**City of Seattle**  
Seattle Public Utilities

**SUBJECT:** Henderson Basin 44 and 45 CSO Reduction Project  
Addendum to Final EIS, Revised Final EIS, and Determination of Non-Significance

**Henderson Basin 44 and 45  
CSO Reduction Project**

Addendum to Final EIS, Revised Final EIS, and Determination of Non-Significance

D:\GISDATA\Project\wash\SP\USPU\_Hen\_Addendum\_Revise EIS\Map\_docs\Fig 03-01\_NoiseMonitoringReceptors.mxd 9/23/2013

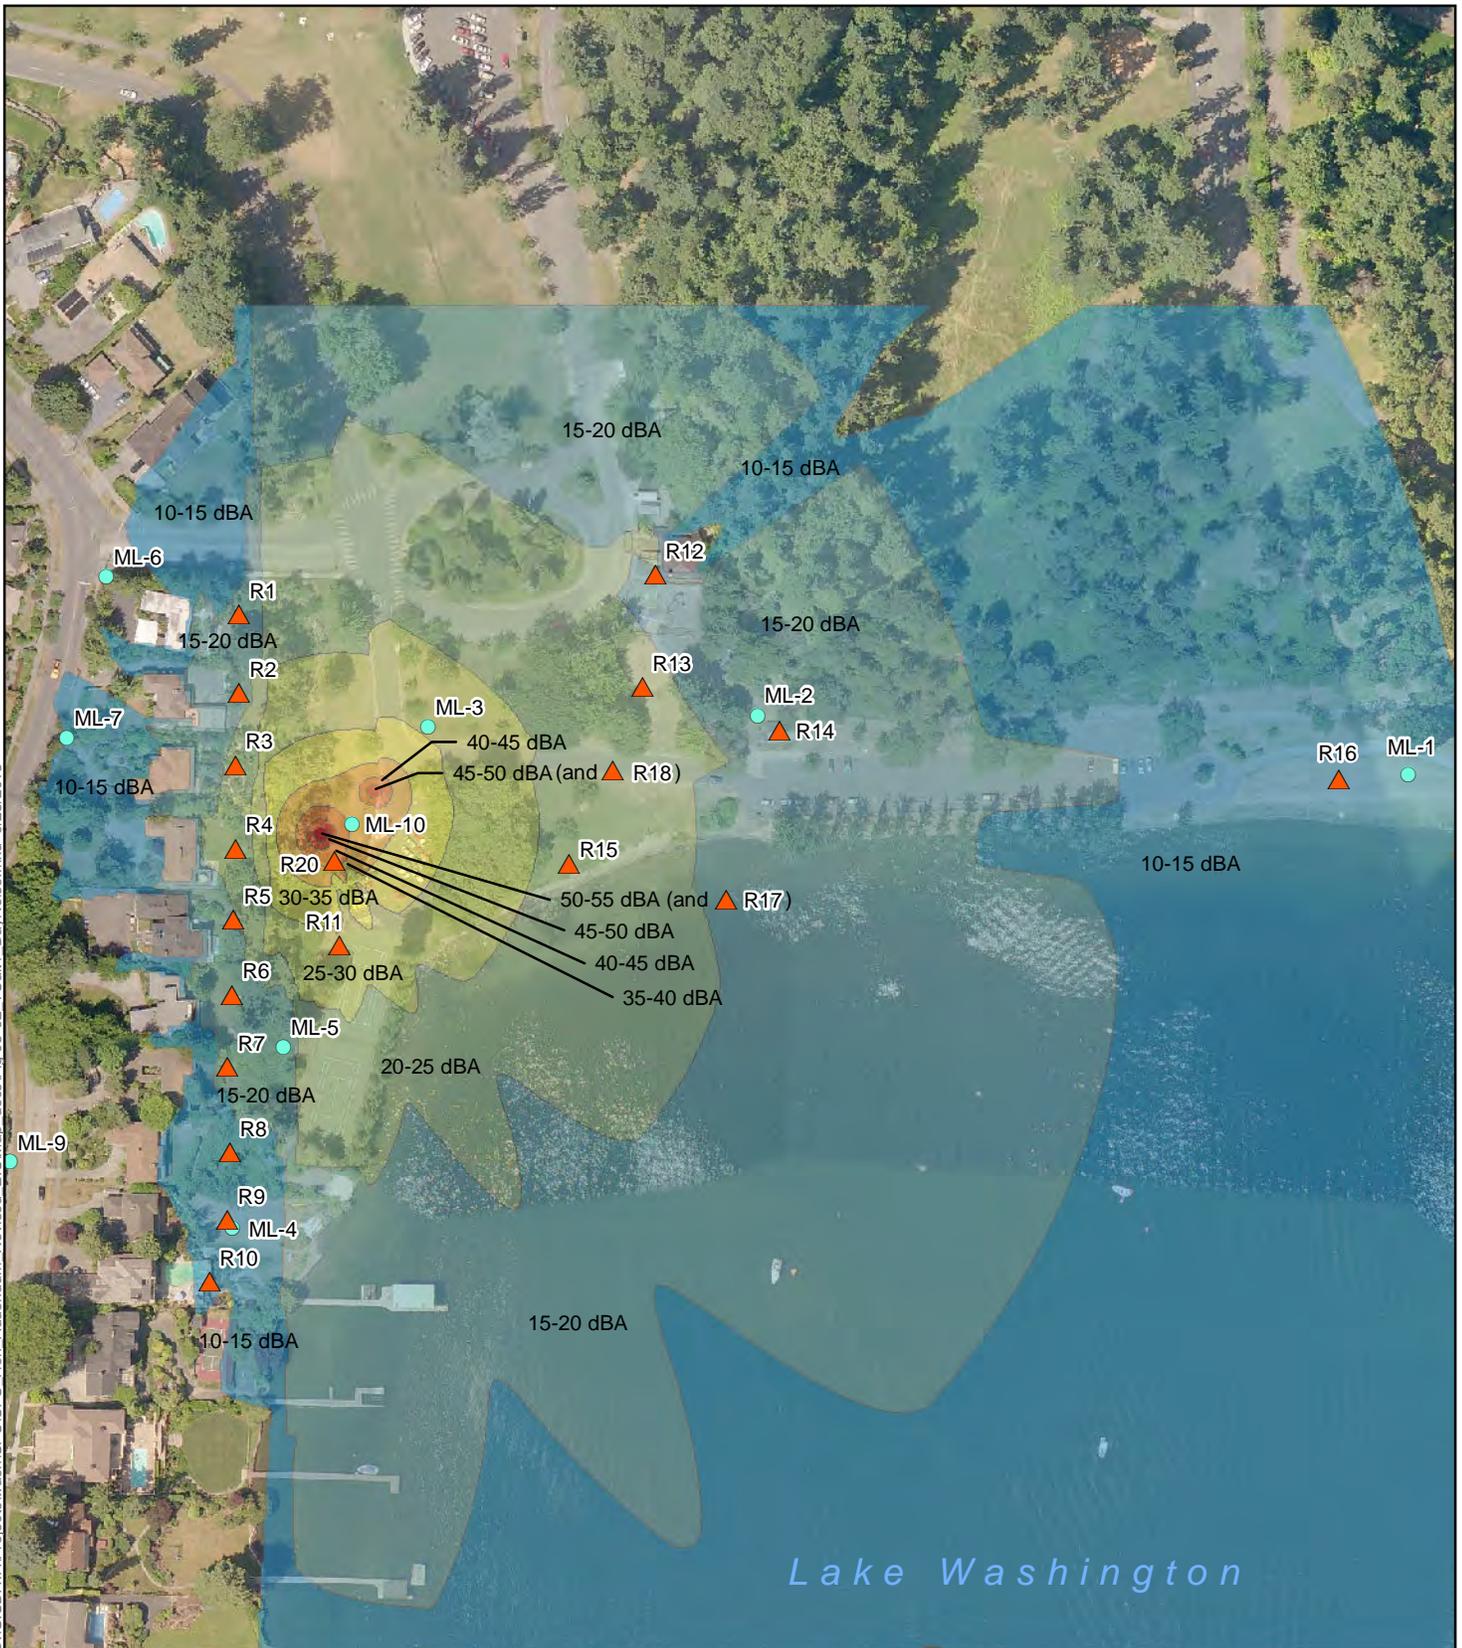
The noise model developed for the 2013 Revised Final EIS (SPU 2013b) was modified to include the new gates and actuators. See Figure 3-1 for the noise monitoring and receptor locations used in the model. The results of the modeling effort are shown in Table 3-1 and Table 3-2 and in Figure 3-2 and Figure 3-3 for the Tennis Courts Alternative and Figure 3-4 and Figure 3-5 for the Parking Lot Alternative. As shown in the tables and figures, the project noise, including addition of the motor actuators, meets the noise design criteria. Conclusions from the noise analysis are as follows:
